ASHBY USA, LLC

Ref: WPN: 10-3020657.02, 18-2001091.02:schwk
NOV No. R9-2006-0135

Subject: Required Technical Report

Ashby USA
Notice of Violation Response
Photos
November 28, 2006

Outfall headwall from sediment basin with rip rap for Phases 1-5

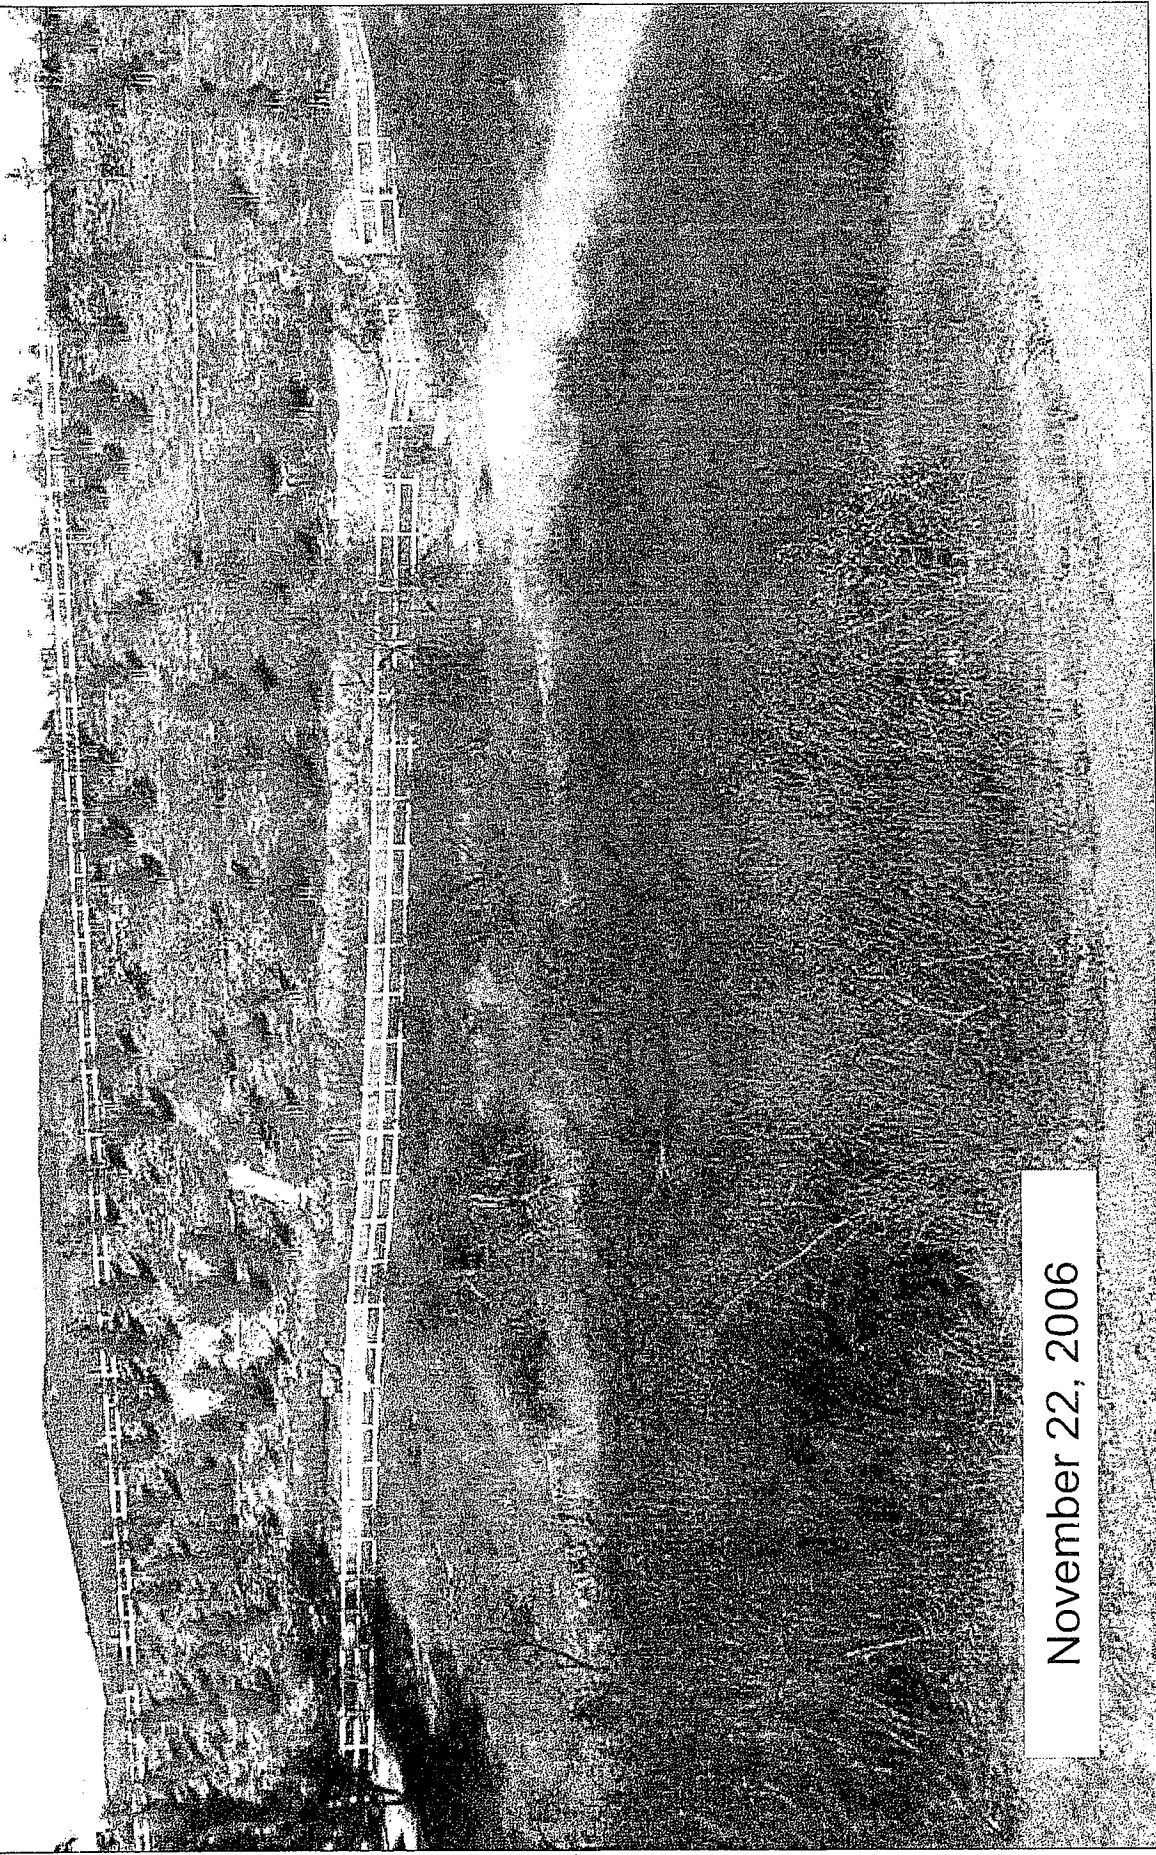
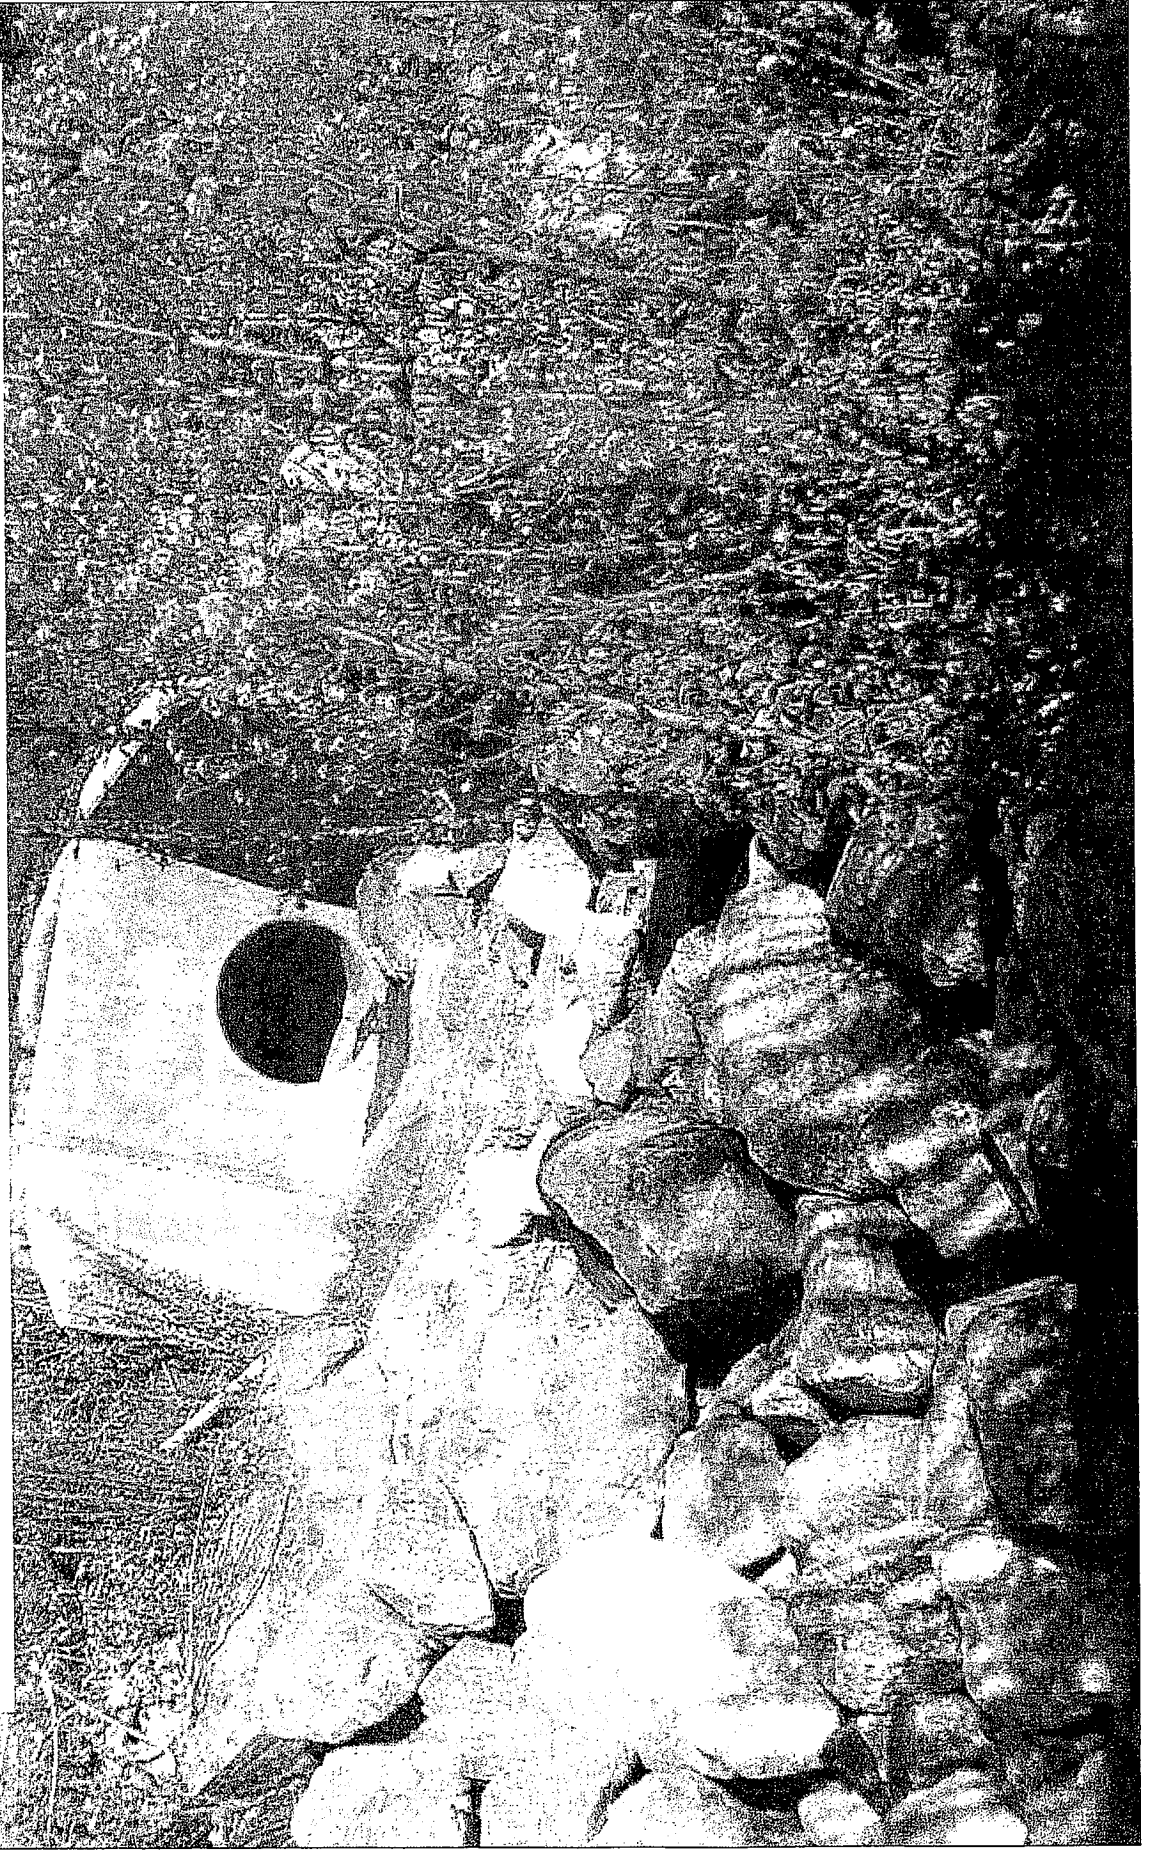
The rip rap at the headwall appeared ineffective in minimizing downstream erosion. The rip rap was covered with sediment eliminating its usefulness in reducing the velocity and energy of concentrated storm water flows from the sediment basin.

These impacts were addressed in NOV R9-2003-0197 issued April 22, 2003, NOV R9-20030392 issued on November 4, 2003, and ACL Order R9-2003-0302 issued on November 12, 2003. As a result of these violations, the following significant construction and post construction BMP's were installed per the direction of the City of Temecula, the discharge point was reduced to a 6" opening; the rip rap at the discharge point was increased. As well as the fact that all season BMP's on the plateau include Silt fencing and wattle on all lots, Storm Drain inlet protection with filter fabric with gravel bag dams. Photo 10 of the inspection report is inaccurate, as shown in the photos in exhibit "A" it is clearly identified that the outlet of the detention basin is on the Roripaugh Ranch Property, photo 10 from the NOV identifies an abandoned check dam that was placed in 2003 and it is not on the Roripaugh Ranch Project as located by the proximity of the property line fence in the background (white rail fence). As directed by the City of Temecula a secondary downstream rip rap area was added to further reduce velocity. Gravel bag check dams have also been placed between the primary and

secondary rip rap to reduce velocities for any additional seasonal flow. Please see the photos in exhibit "A" to view existing conditions.
